# TECHNICAL INFORMATION COMMUNICATION

Number: TIC2017-0005 Date: 4/28/2017

Title: Base Pan Short Fork Protection

Product Category: Small Rooftop Units Chassis 1 & 2, 3-6 ton

(Figure 1) - Brackets and Mounting Screws

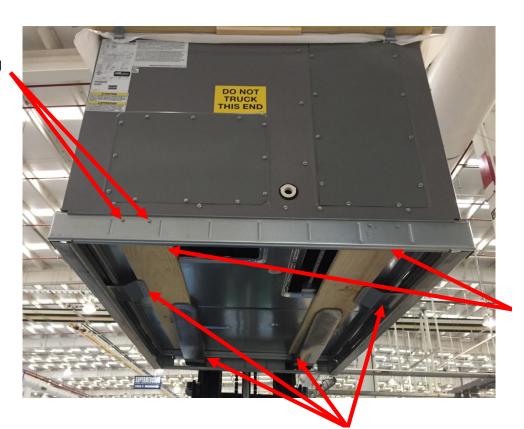
Two pieces of wood have been added to the bottom of the units to protect the base pan from short-forking damage. These pieces of wood are secured with brackets and screws.

The two pieces of wood must be removed before installation. For each piece of wood, there are three metal support brackets, each secured to the baserail with two screws to secure the wood in place. Remove the 12 mounting screws as shown in (Figure 1). Discard the wood and brackets. Failure to remove the wood and brackets will interfere with the ductwork installation. When forking from the side, ensure the forks remain level until full engagement before tilting. Failure to do so could result in the forks going between the wood and base.
